RESPONSE TO REQUEST FOR ADDITIONAL INFORMATION

US-APWR Design Certification

RAI NO.: NO. 1060-7285 REVISION 0
SRP SECTION: 03.07.02 – Seismic System Analysis
APPLICATION SECTION: 3.7.2
DATE OF RAI ISSUE: 11/15/2013

QUESTION NO. 03.07.02-239:

Figure 1 - First Out-of-Plane Mode from ANSYS Detailed Model (uncracked) of the West PS/B Wall

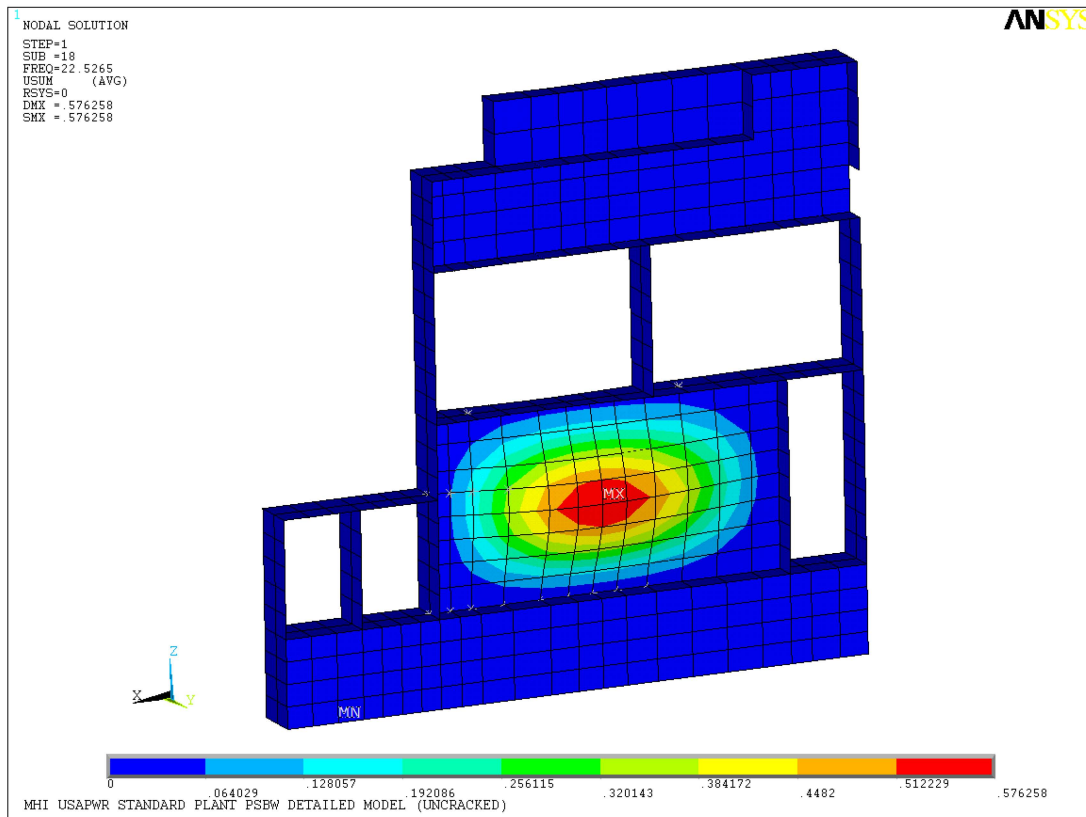
In Section 02.4.1.1.2 “Discretization Considerations: Mesh Size,” of MUAP-10006, “Soil-Structure Interaction Analysis and Results for the US-APWR Standard Plant,” Revision 3, the applicant presents an adequate description of its approach to ensuring that the ANSYS dynamic model is capable of accurately picking up out-of-plane slab vibration modes up to 70 Hz, for uncracked concrete properties. However, the staff needs additional information relating to modeling of flexible walls before it can complete its evaluation of the adequacy of the ANSYS dynamic model. To assist the staff, the applicant is requested to submit comparisons between fundamental frequencies based on classical plate vibration formulas and those computed using the ANSYS detailed model and the ANSYS dynamic model, for all walls that have out-of-plane fundamental frequencies below 70 Hz, in order to demonstrate that the ANSYS dynamic model discretization is adequate to predict the out-of-plane flexural deformation. If the element mesh for a particular wall is not adequate, discuss how the additional amplification at the center of the wall will be calculated.

The discretization of the walls in the dynamic model for soil-structure interaction analysis is adequate for the following specific case. In order to demonstrate that the mesh size for the out-of-plane frequencies of the uncracked walls with a fundamental frequency below 70 Hz is reasonable, one of the most flexible wall (55' long x 29' tall x 1'-8" thick) located at column line 7R in the west Power Source Building (PS/B) is examined as an example. The results of modal analysis performed on the west PS/B, as part of the work to validate the dynamic model documented in Technical Report MUAP-10006, Rev. 3, are shown in Figures 1 and 2 for the first local out-of-plane mode from both the benchmark detailed model and the dynamic model, respectively. The fundamental frequencies for the examined wall segment are also calculated using classical plate vibration formulas from Roark's for two support conditions at the four edges (Table 16.1, cases 15 and 16, Roark's Formulas for Stress and Strain, Seventh Edition): fixed and pinned. Table 1 lists the calculated frequencies and the ANSYS results. The ANSYS results from the dynamic and detailed models match very well

with each other, and they are bounded by the classical solutions for the fixed and pinned conditions as expected. Thus, the responses of this wall from the dynamic model will provide accurate in-structure response spectra for the design of equipment that may be attached to the wall.
